**MCDONALD'S RESTAURANT**  
**10950 S. Parker Road**  
**Parker, Colorado**

**DRAINAGE REPORT**

Revised: October 10, 2025

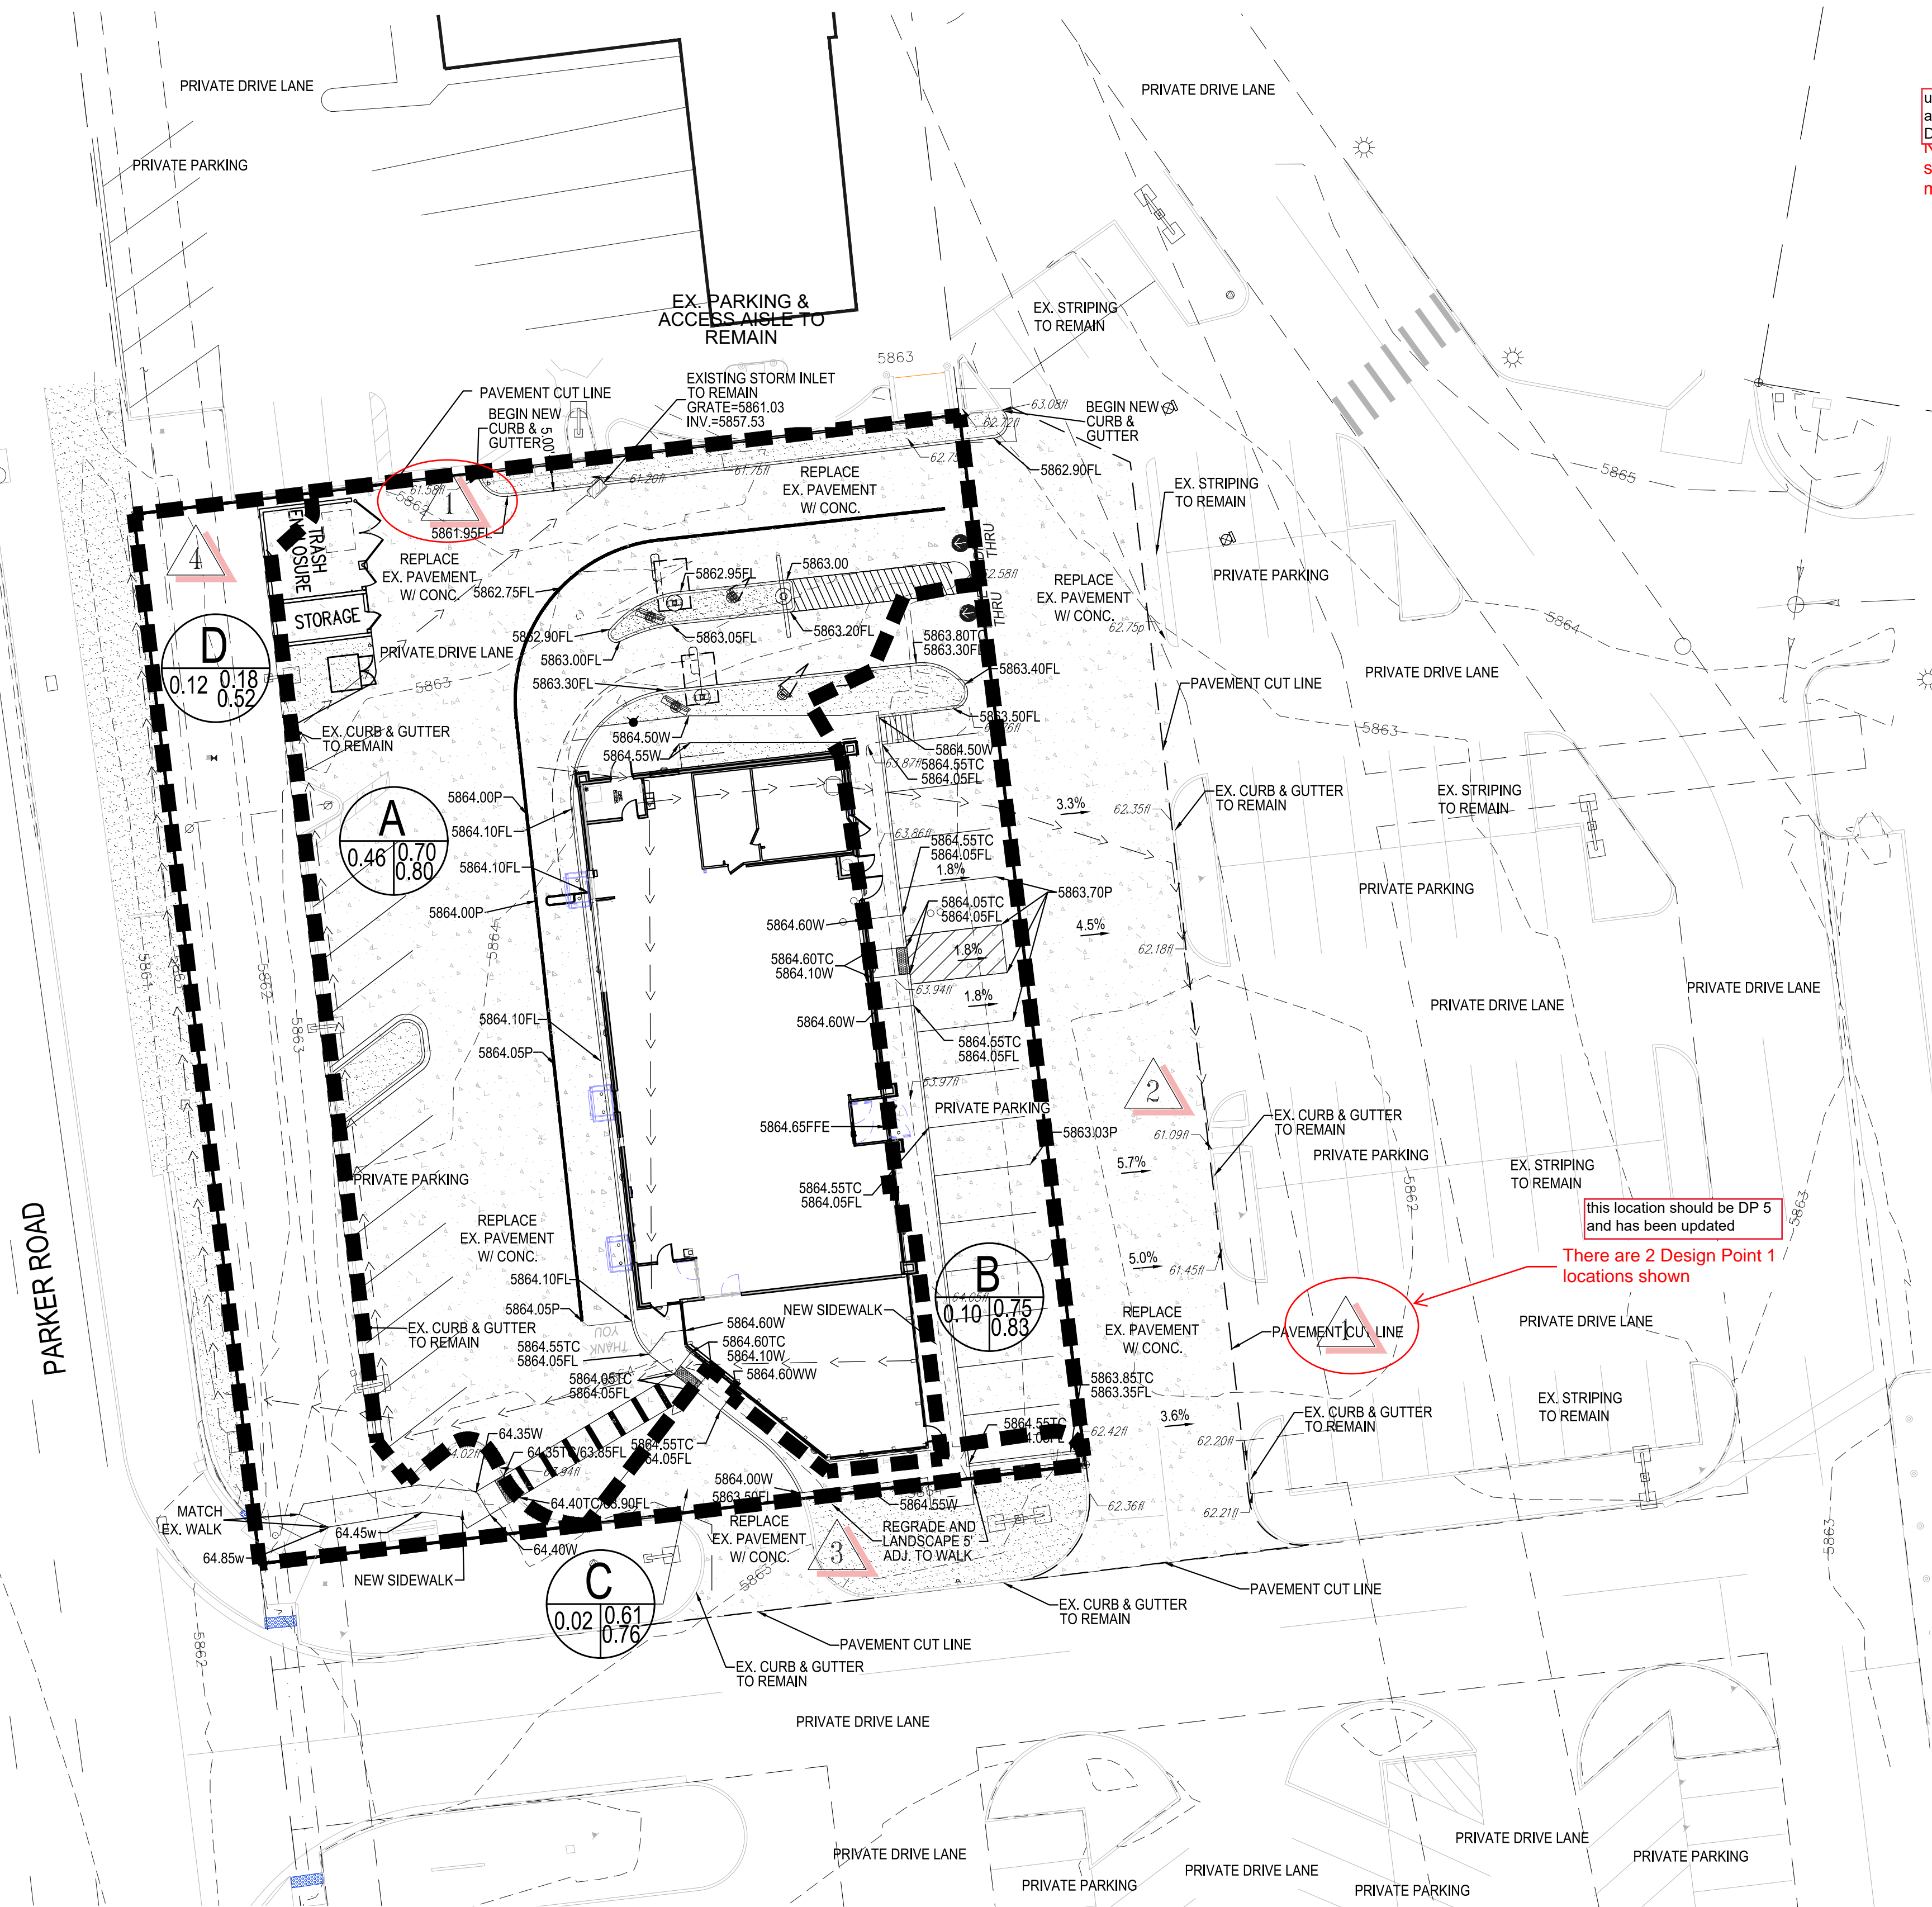
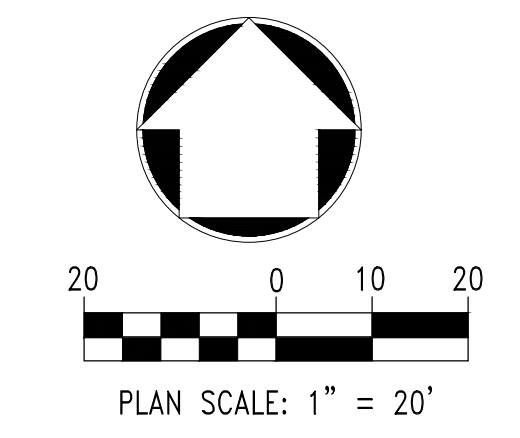
updated below, this is a peak site discharge DP  
No Design Point 5 shown in the basin map

this location should be DP 5 and has been updated  
There are 2 Design Point 1 locations shown
